MATANUSKA-SUSITNA BOROUGH

ABBREVIATED PLAT AGENDA
ASSEMBLY CHAMBERS
350 EAST DAHLIA AVENUE, PALMER

REGULAR MEETING **8:30 A.M.** **May 13, 2026**

STAFF REVIEW AND RECOMMENDATIONS
PUBLIC HEARING
MAY 13, 2026

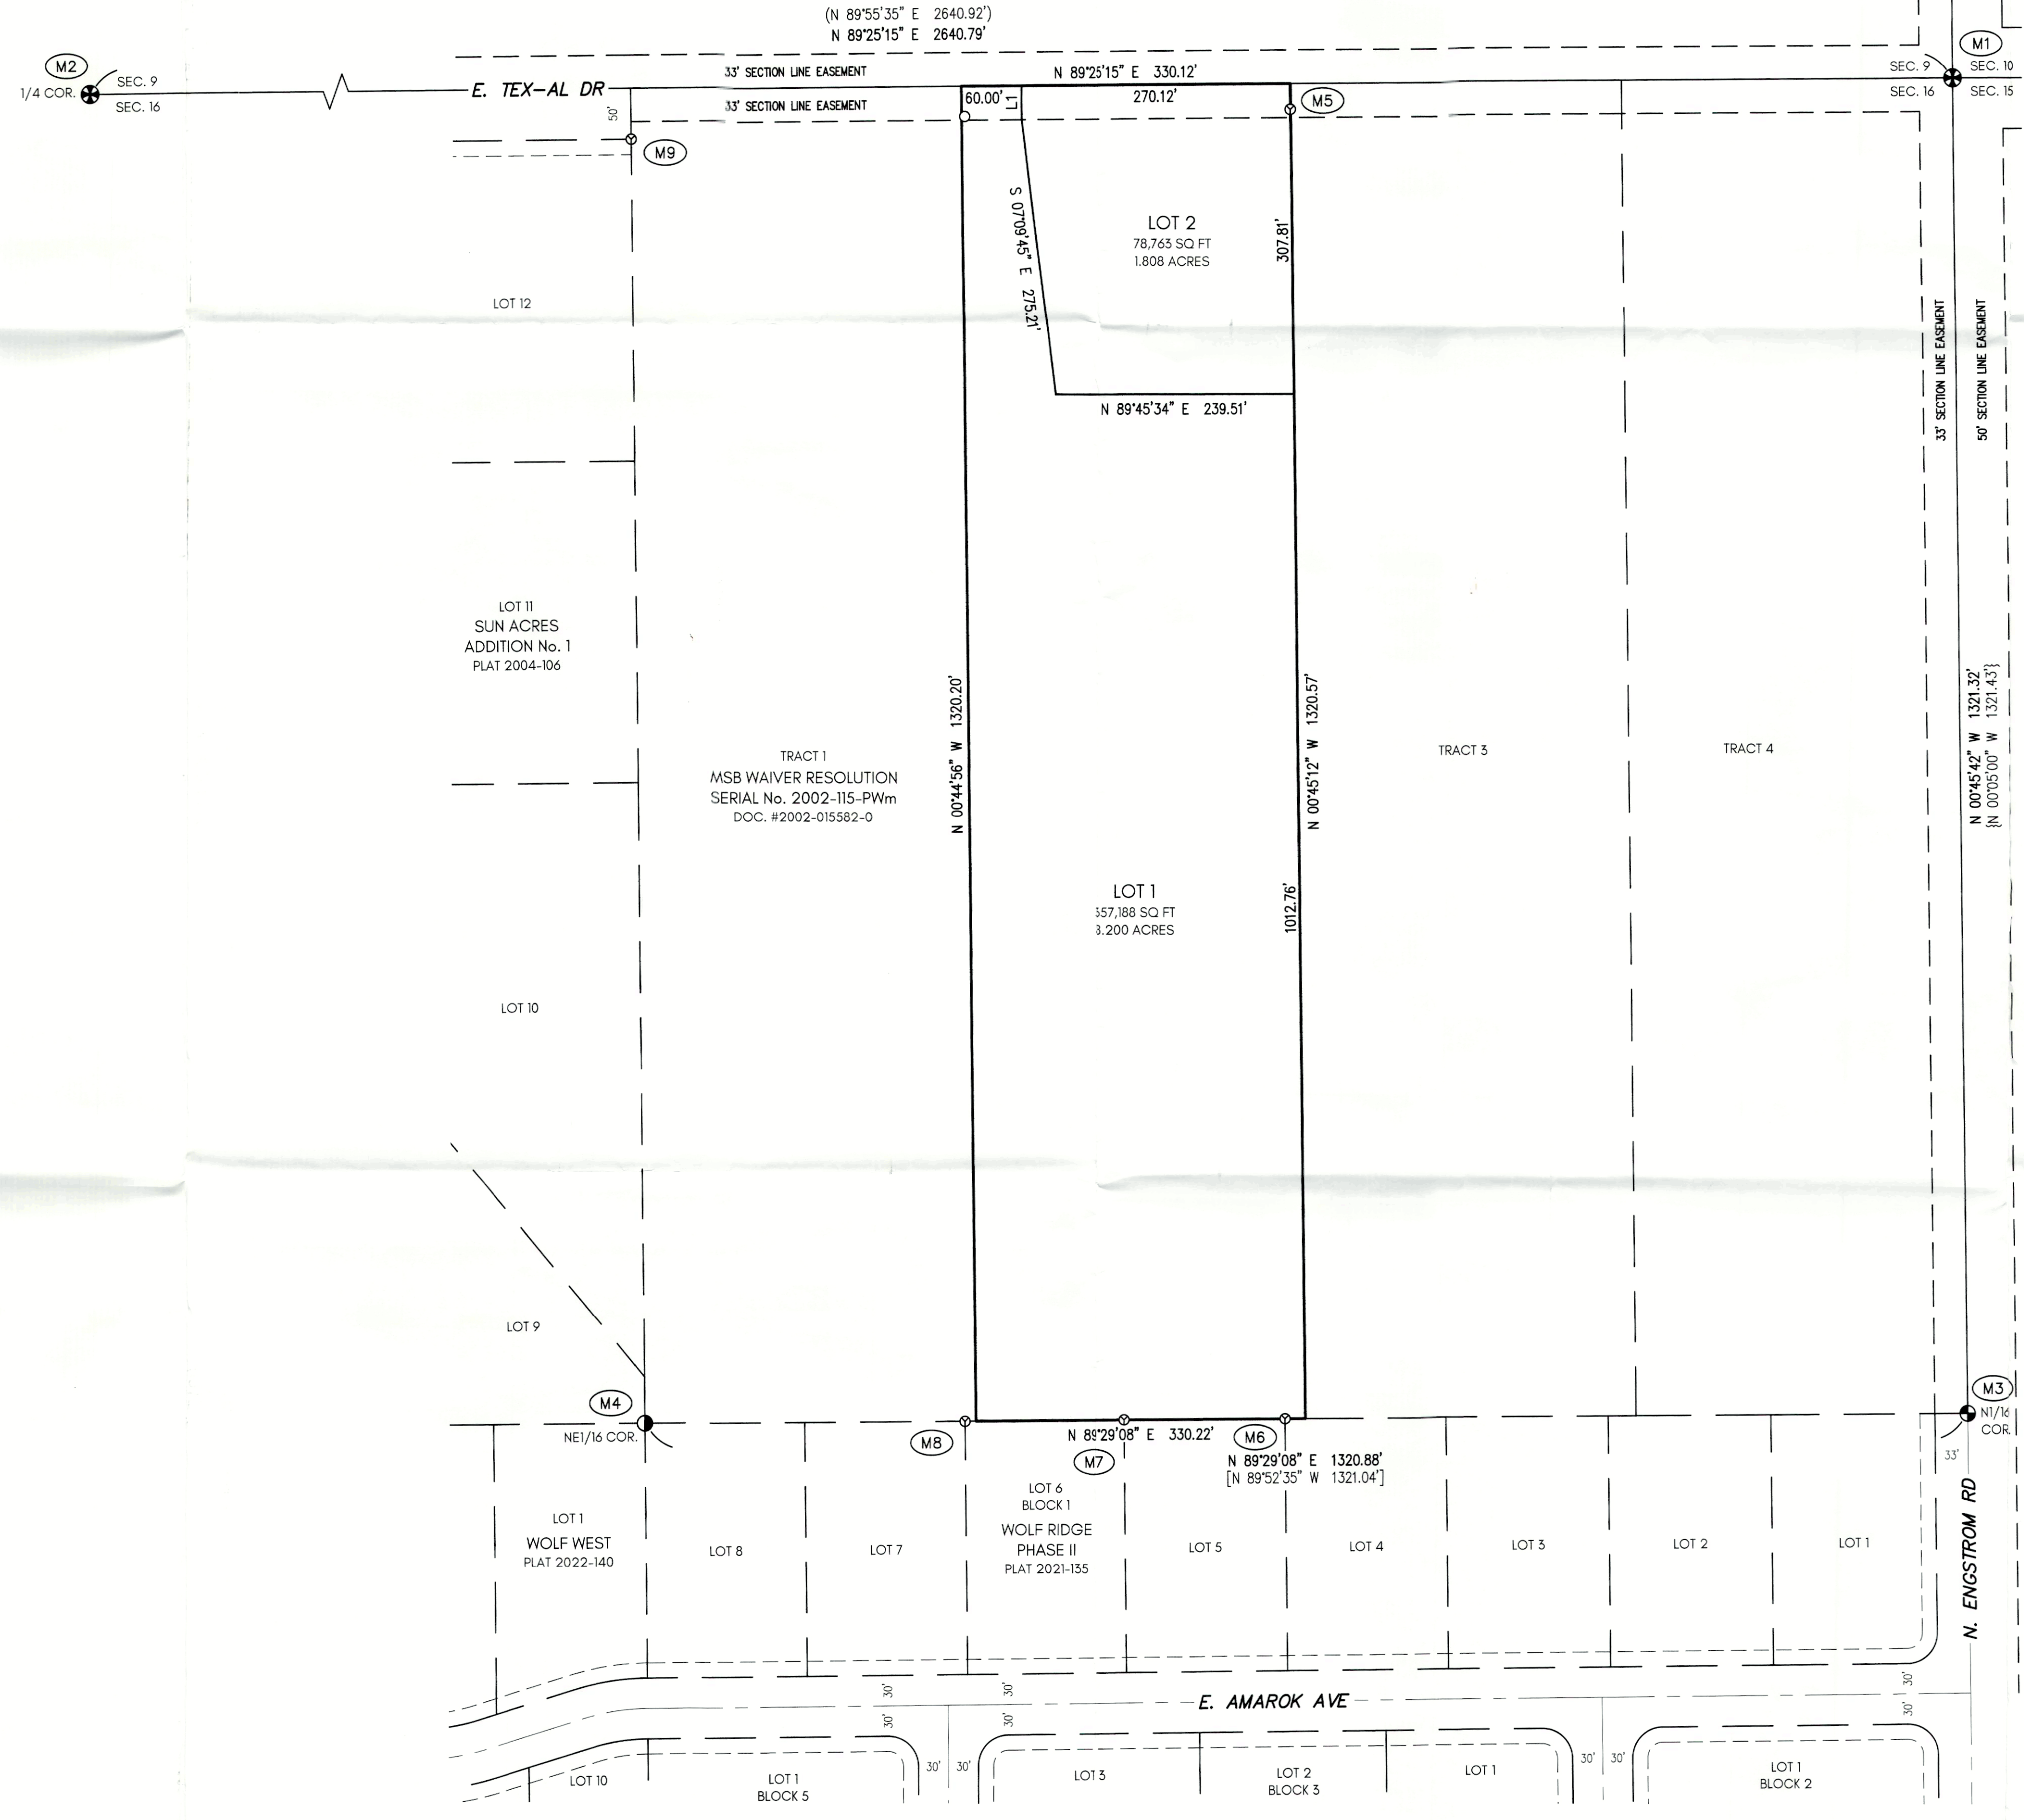
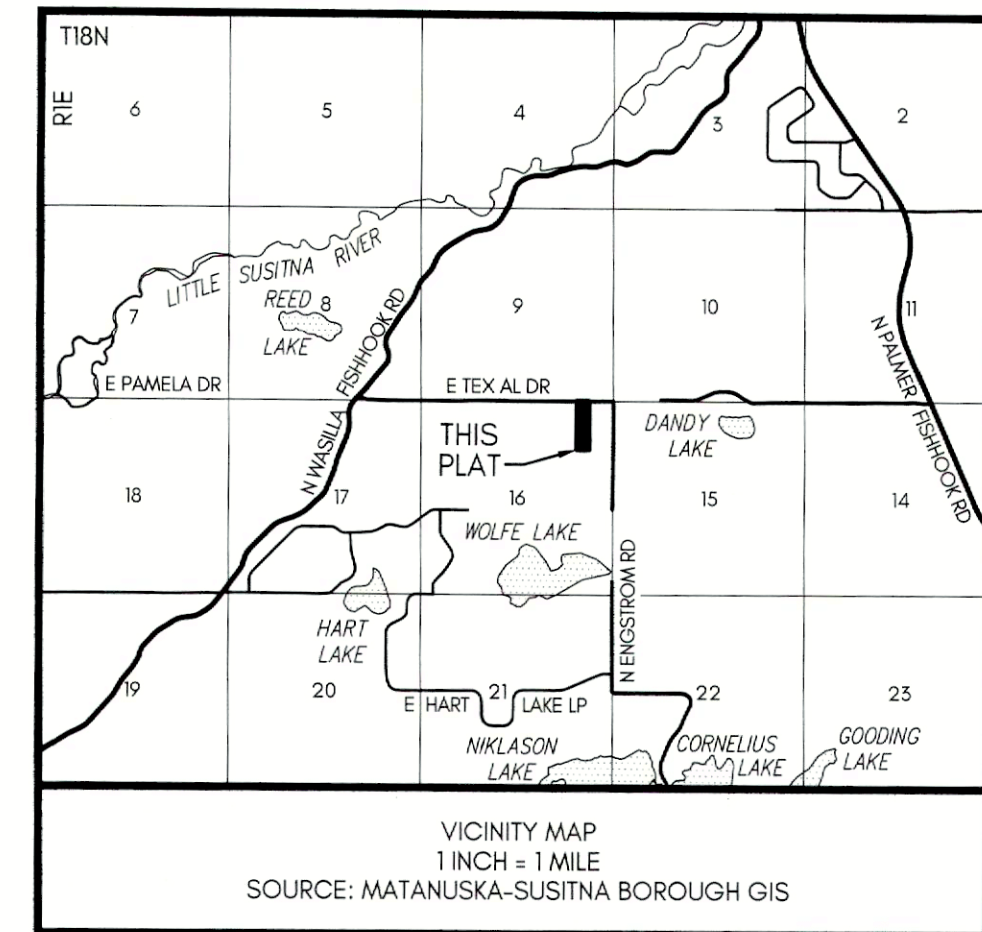
Tex-Al Drive is classified as a major collector on the OSHP. The proposed lots should share a single access point. A common access easement shall be shown on the plat.

ENSTAR Natural Gas Company, LLC (ENSTAR) has reviewed the abbreviated plat for RUNWAY RIDGE proposed under MSB Case 2026-40 and advises that said property is subject to an existing natural gas right of way easement, dated September 22, 2017, and recorded September 25, 2017, under Serial Recording No. 2017-022659-0 in the records of the Palmer Recording District, Third Judicial District, State of Alaska. ENSTAR objects to this plat unless one of the following scenarios is met:

1. Said easement is depicted as described in the proposed plat map and referenced in the notes of said plat.

3. Pay postage and advertising fees.
4. Proposed lots should share a single access point, a common access easement to be shown on the plat.
5. Natural gas right of way easement, dated September 22, 2017, and recorded September 25, 2017, under Serial Recording No. 2017-022659-0 in the records of the Palmer Recording District, Third Judicial District, State of Alaska; to be depicted on the plat as described in the proposed plat map and referenced in the notes of the plat.

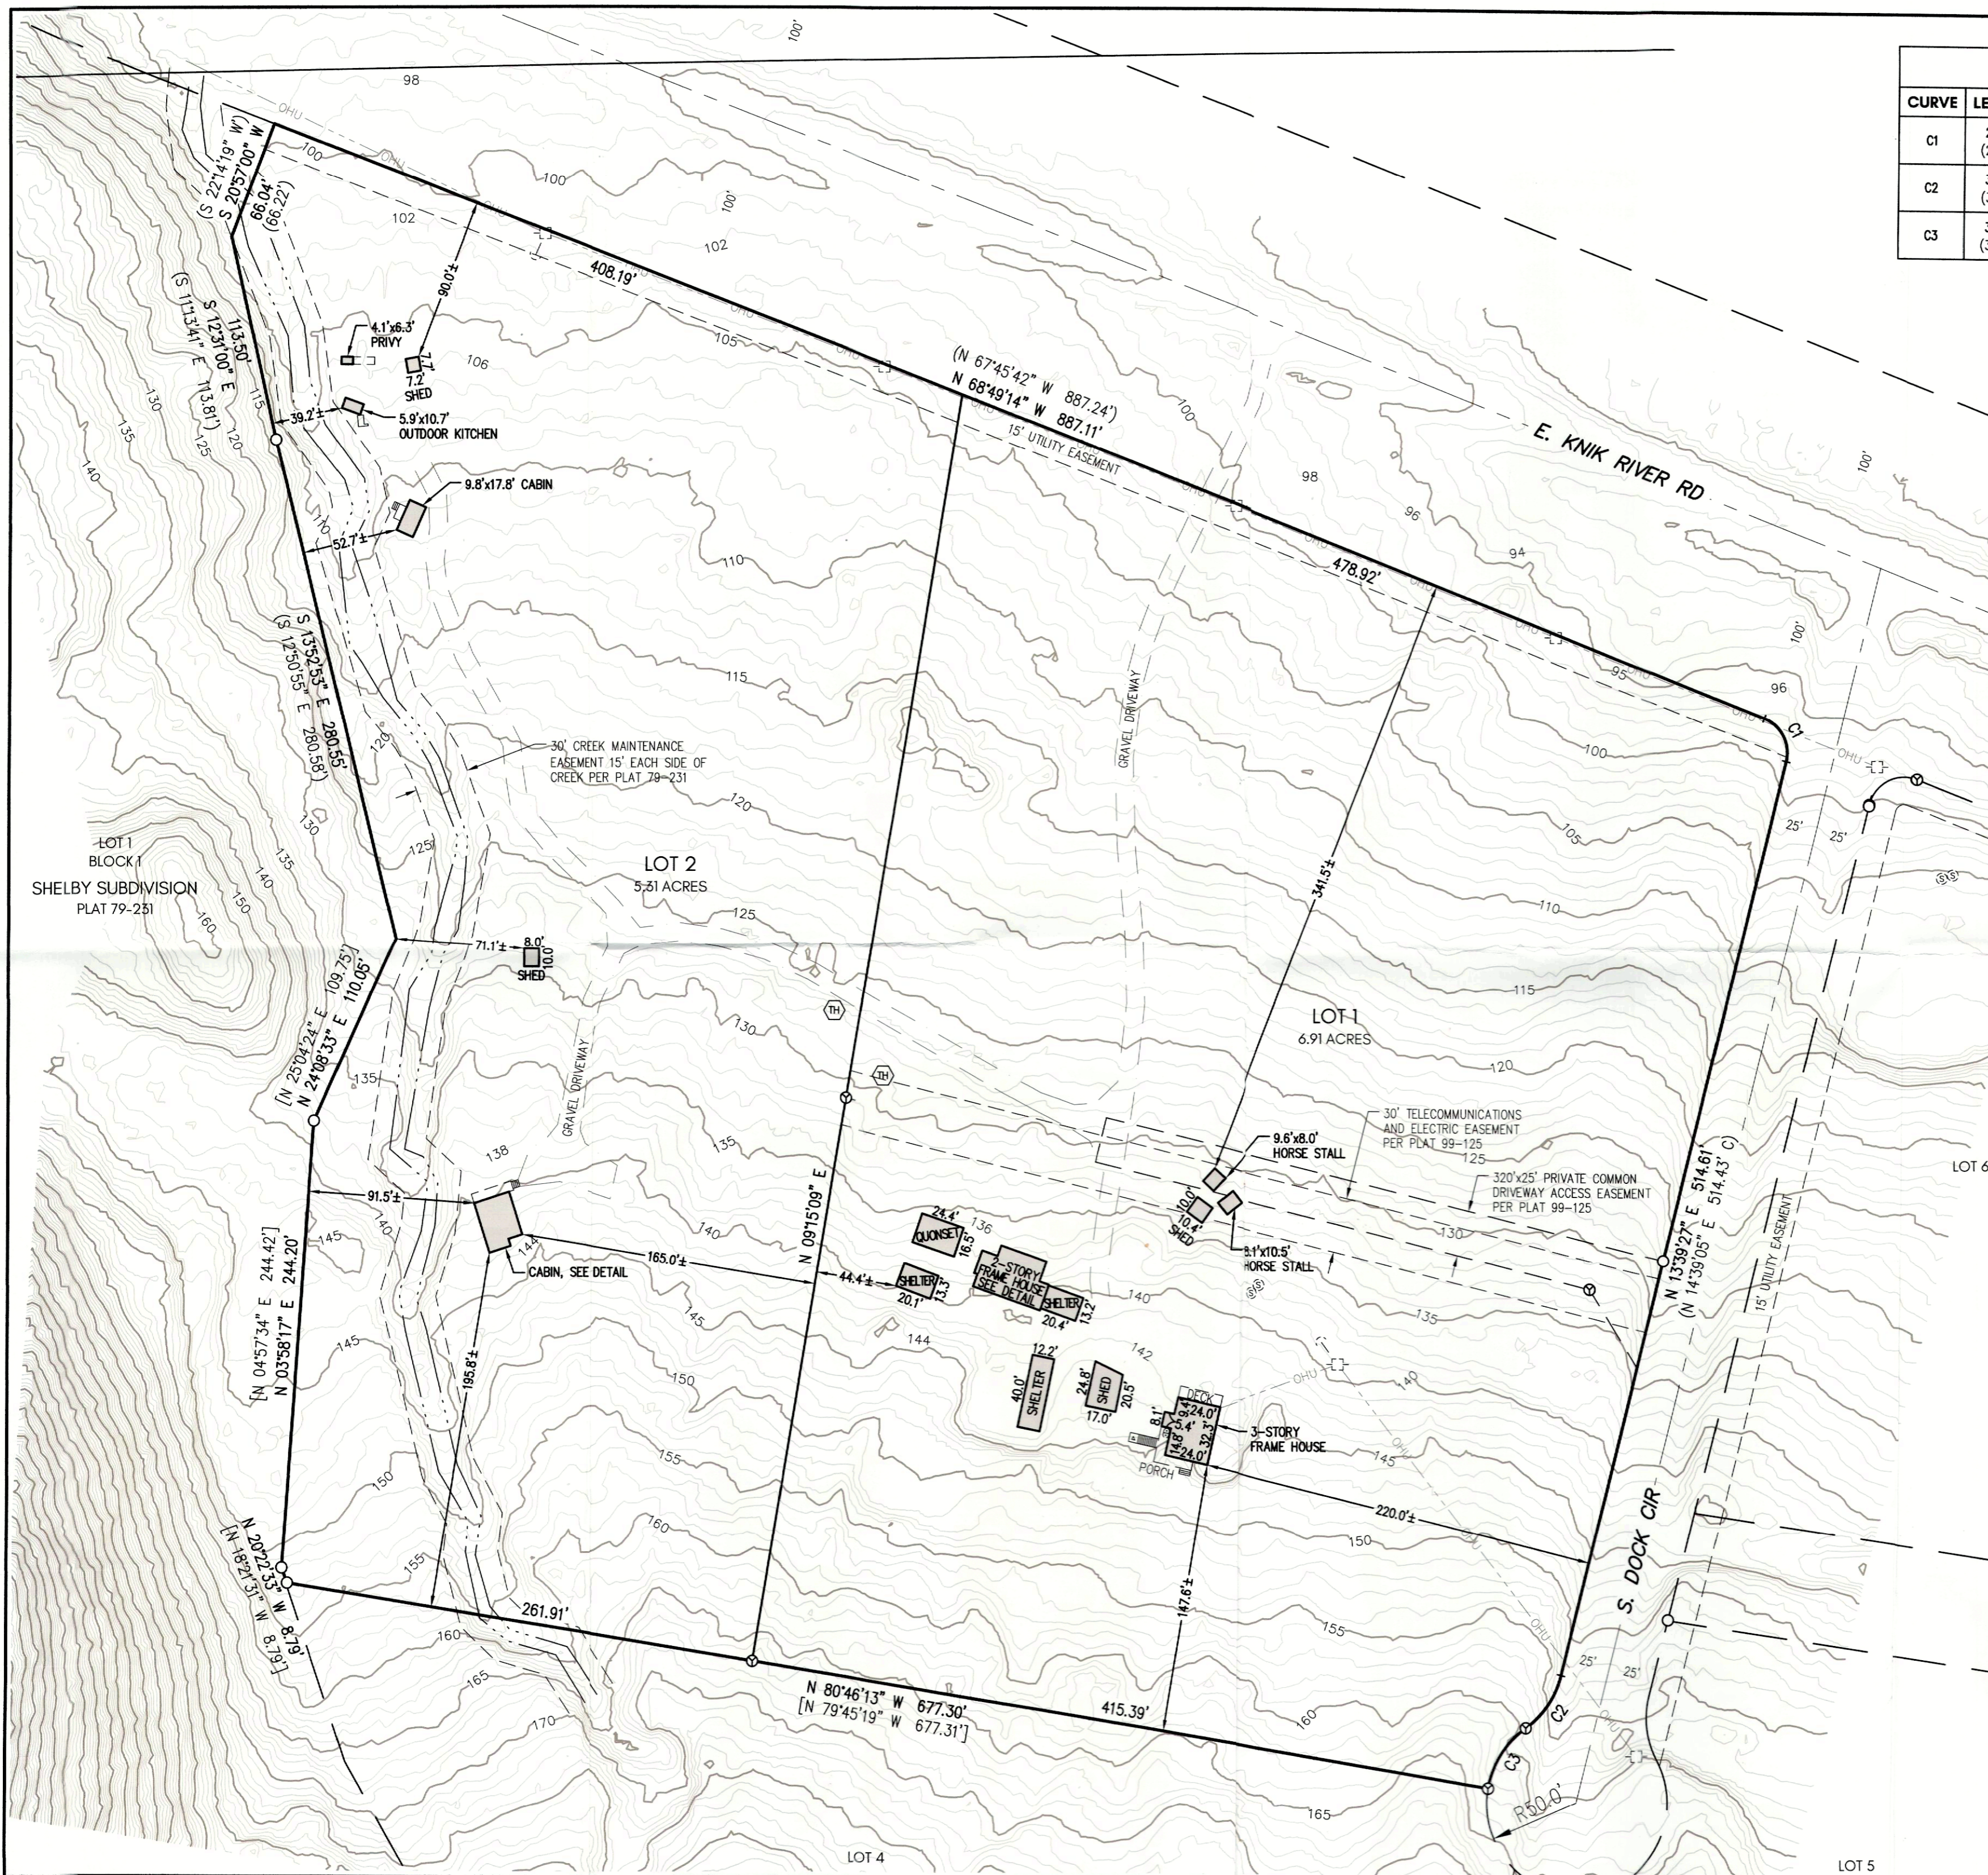
On the Topo & As-built PDF – it shows two horse stalls that are within the platted “private common driveway access easement per plat 99-125”. Private access will need to be adjusted to not have structures within it; or remove the structures.

7. Apply for a driveway permit for the existing access to S. Dock Circle. Provide Platting Staff a copy of the submitted driveway permit application.
8. Provide staff with proof that all Title 17 setback violations have been resolved.
